AGENDA
Regular Hybrid Meeting
Town of Granby
Inland Wetlands and Watercourses Commission
Wednesday, July 9, 2025, at 7:00 pm
Town Hall Meeting Room

Site Plan Review for Inland Wetlands Application

Plan: "Preliminary Site Plan Application Plans for AutoZone Granby, 8 E Granby Road, Granby, CT 06035, Date: 5/13/2025, Sheets C-0.0 through C-6.2, Kimley-Horn & Associates, Inc, Revised 7/01/25."

This letter is being submitted by Kimley-Horn & Associates, Inc. on behalf of AutoZone, Inc. ("Applicant") in response to the department review letters listed below:

SHEET 1 OF 1

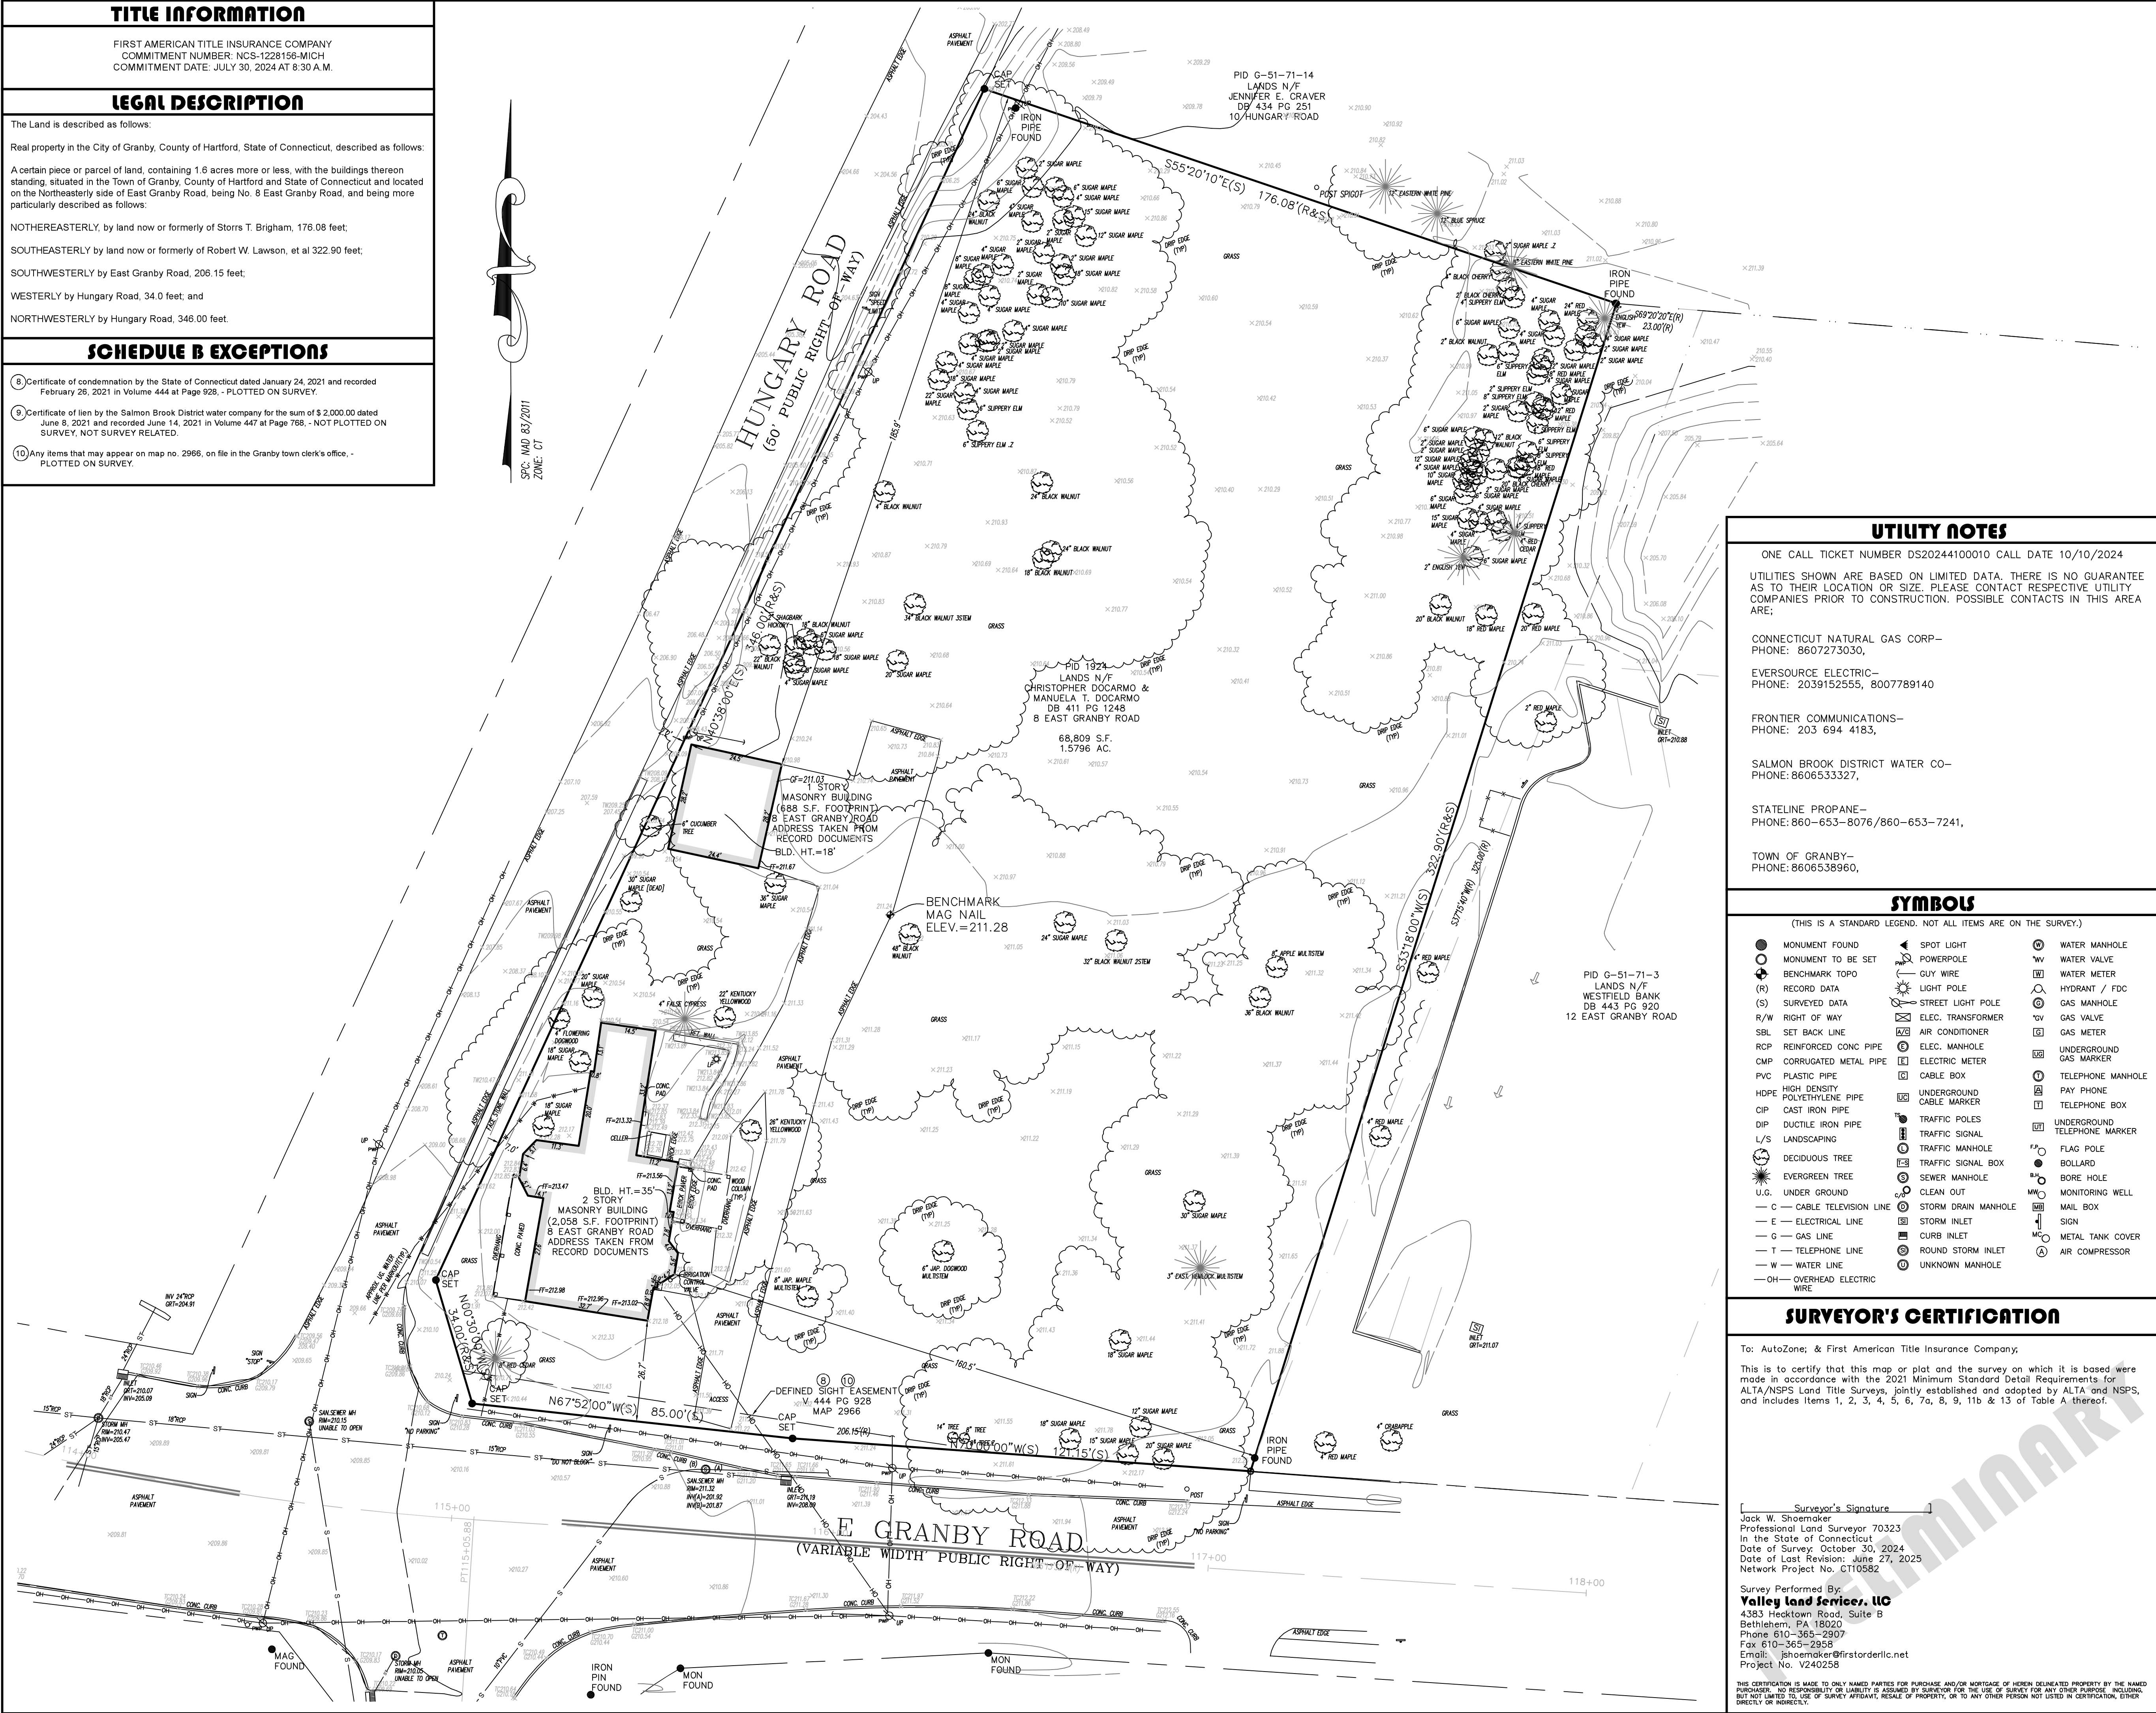
1. Show and label existing sidewalk.

2. Show existing information easterly from site past the property line by about 20-feet.

3. For the trees to shown on the survey that are to remain, show their existing drip line.

5. The tree line shown on Sheet 1 of 1 the Site Survey and subsequent site plans shows the westerly tree line type indicating that the tree line is located to the east. It appears that this is intended to indicate that the tree line is located to the west, along Hungary Road. Please confirm.

Response: The survey has been revised to include the existing information east of the property approximately 20'.

Response: The survey has been revised to show all existing trees on the property and the existing drip line. The civil design sheets have been revised to show which trees are to remain and the remaining drip line.

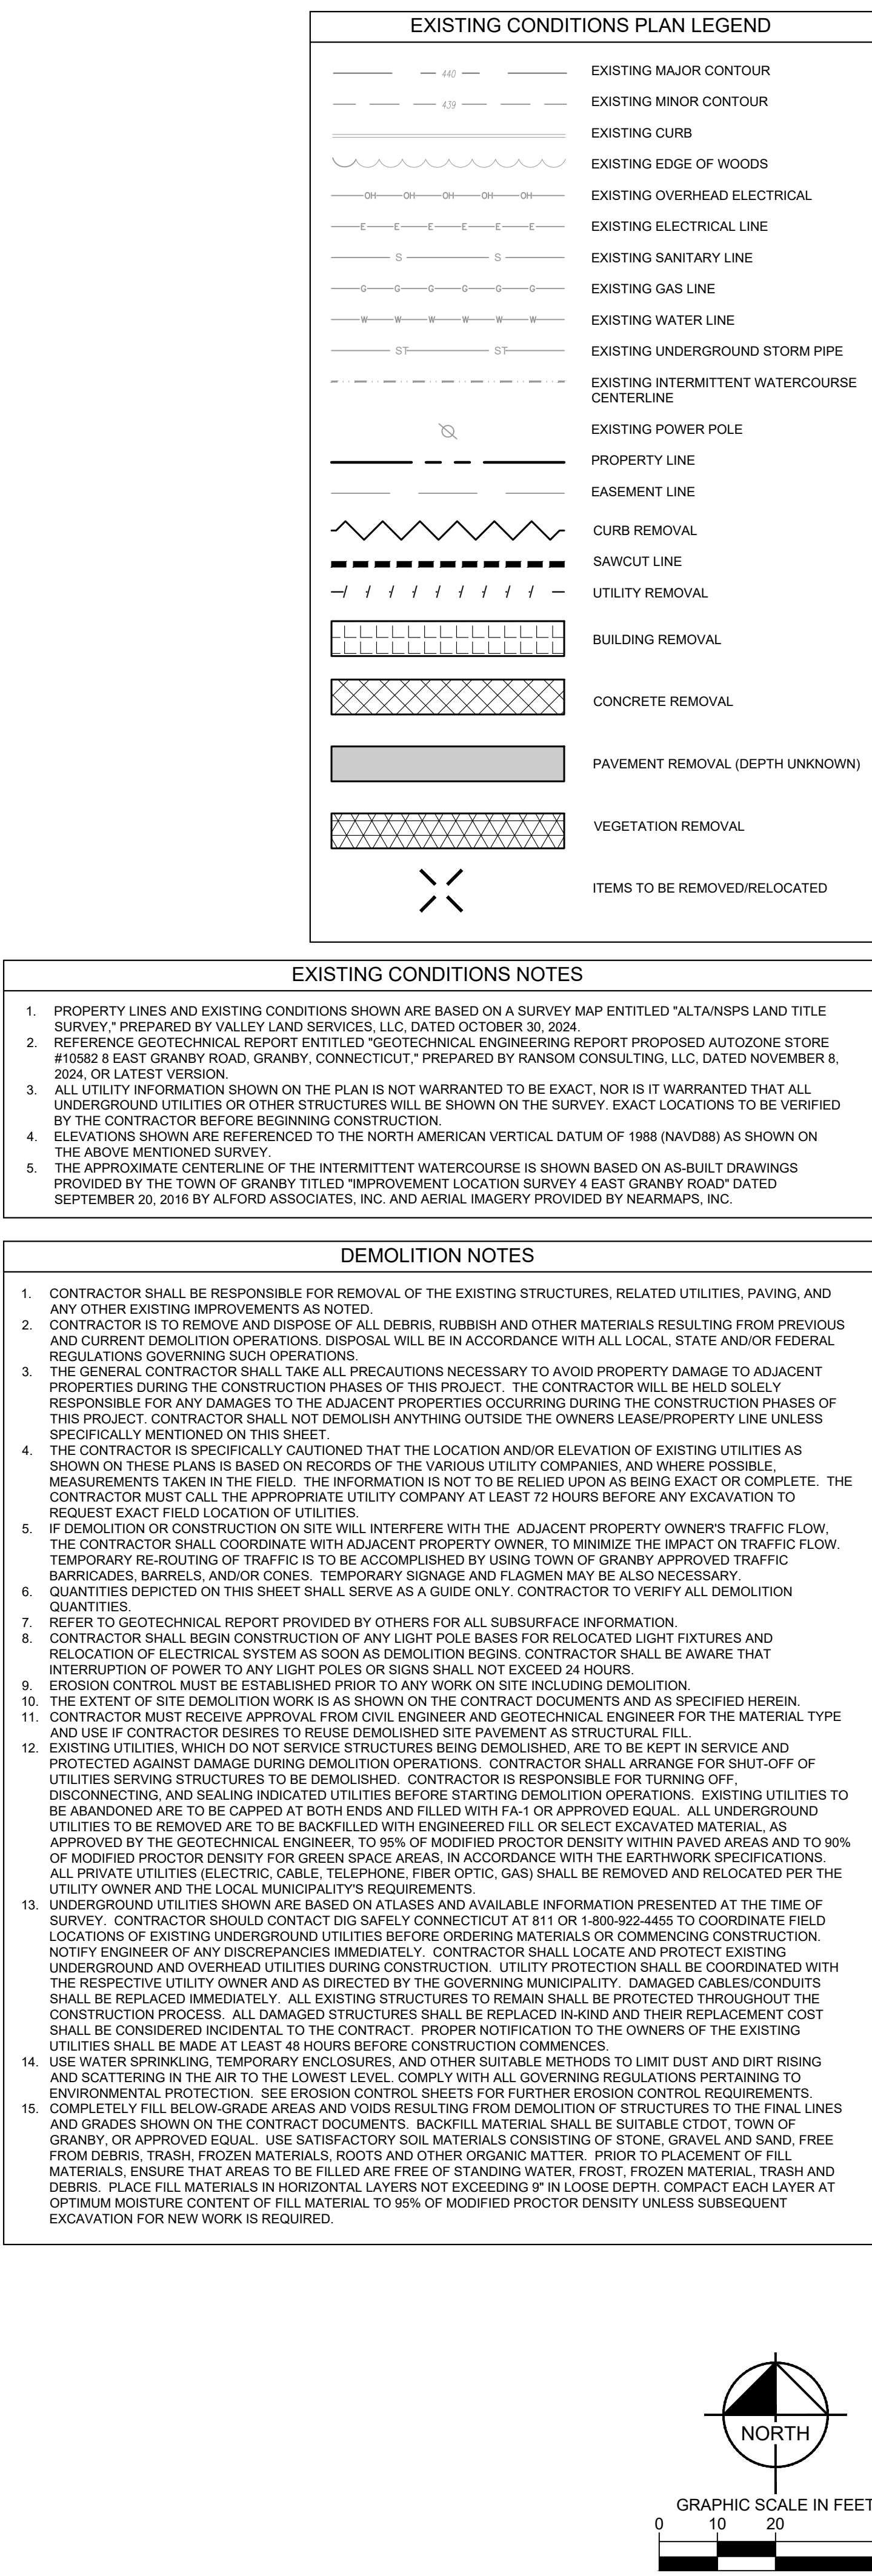
4. Please confirm and supply the reference to how the “Approximate Centerline of Intermittent Watercourse” shown on sheet C-1.0 has been determined.

Response: The centerline of the intermittent watercourse shown on Sheet C-1.0 was determined by as-builts provided by the Town of Granby and aerial imagery. Note 5 has been added to Sheet C-1.0 detailing the determination.

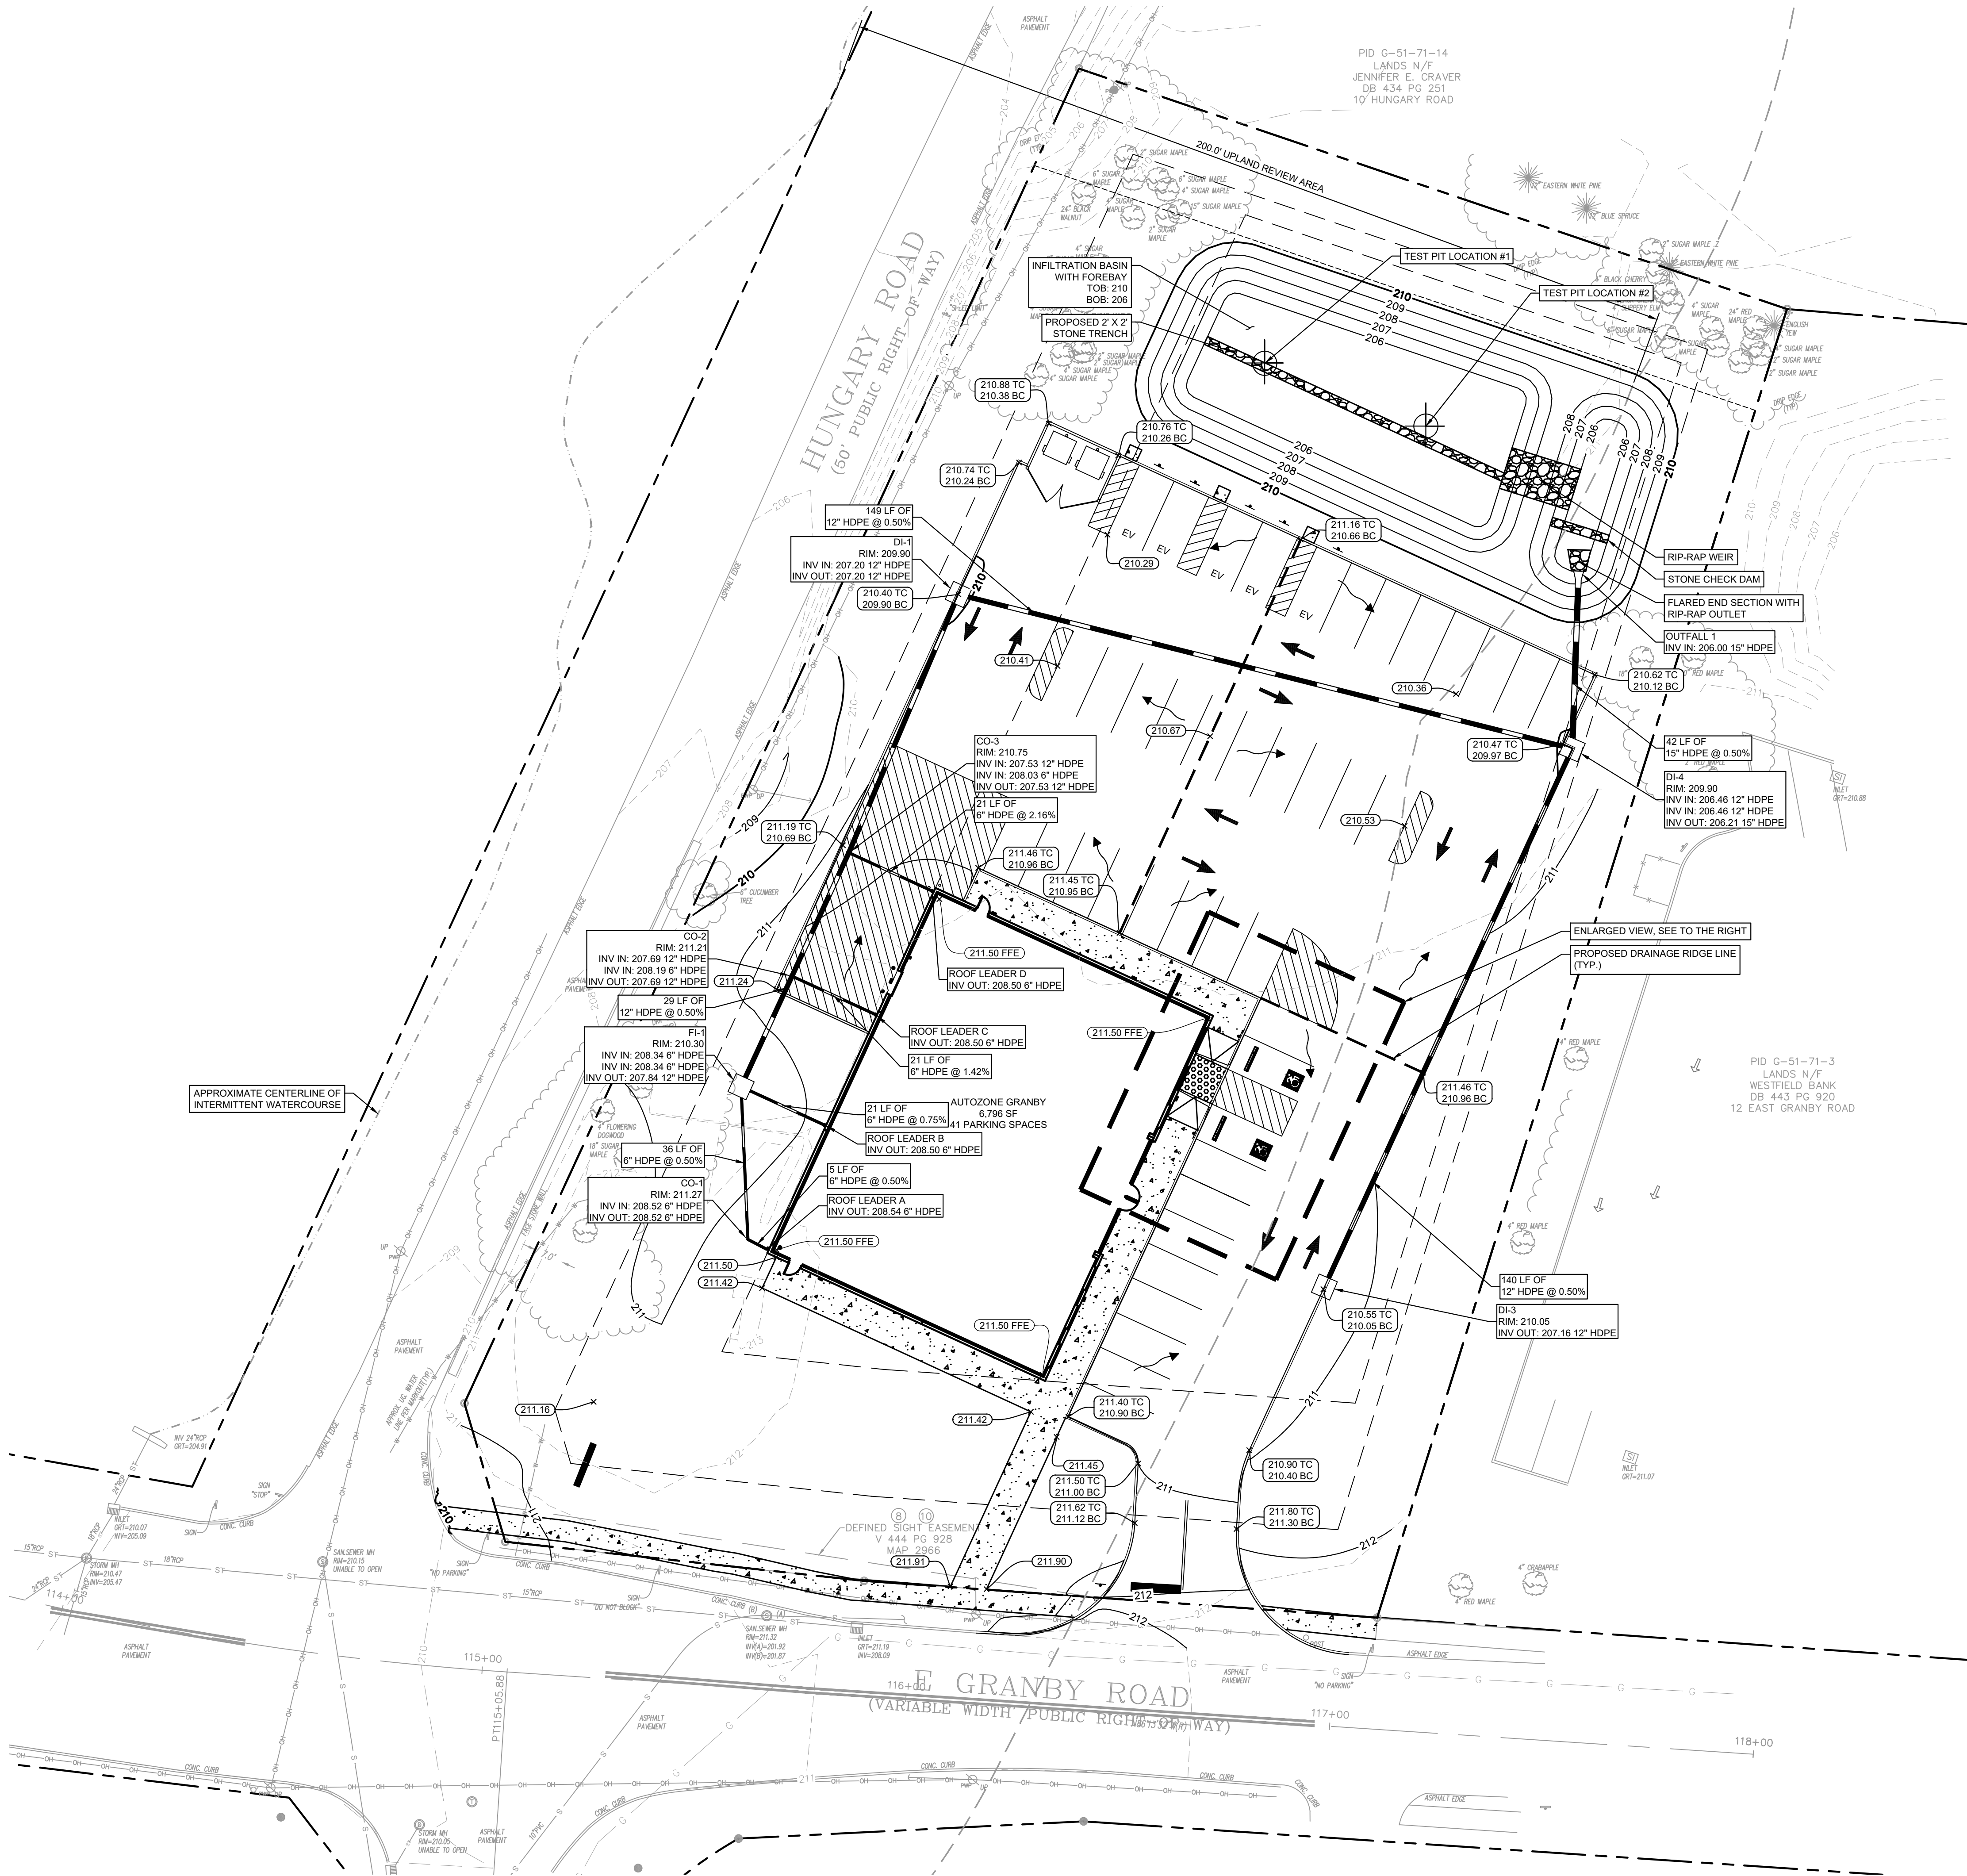
2. Show test hole information on this sheet.

3. Add the test hole pit data to the report and on sheet C-3.0. Test pits and soil data reporting to comply with the Connecticut Stormwater Quality Manual, March 30, 2024, Chapter 10, Test pits and Borings, pages 178 and 179.
4. Concur with the results and conclusions.

4. Add a stone trench at least 2-feet deep in the infiltration area to provide for infiltration during periods of frozen ground.

5. Show additional spot grades in the pavement areas to indicate how the pavement will drain.

17. At least two test pits are required in the proposed infiltration basin to support the design infiltration rate described on page 16 of the Stormwater Management Report. Add the test hole pit to the report and on sheet C-3.0. Test pits and soil data reporting to comply with the Connecticut Stormwater Quality Manual, March 30, 2024, Chapter 10, Test pits and Borings, pages 178 and 179. Refer design infiltration rate to table 10-2 and add it to the drainage report.

Response: The infiltration basin has been revised to include a 2' x 2' stone trench to promote infiltration during periods of frozen ground. A detail of the stone trench is provided on Sheet C-6.1.

Response: Sheet C-3.0 has been revised to include additional spot grades, drainage ridge lines, and drainage flow lines to denote the drainage within the pavement area.

Response: Two test pits were completed on 6/24/25. The results have been added to the stormwater report and the locations are shown on C-3.0. An infiltration rate of 26 in/hr was observed, therefore, a design rate of 13 in/hr is utilized for the design calculations.
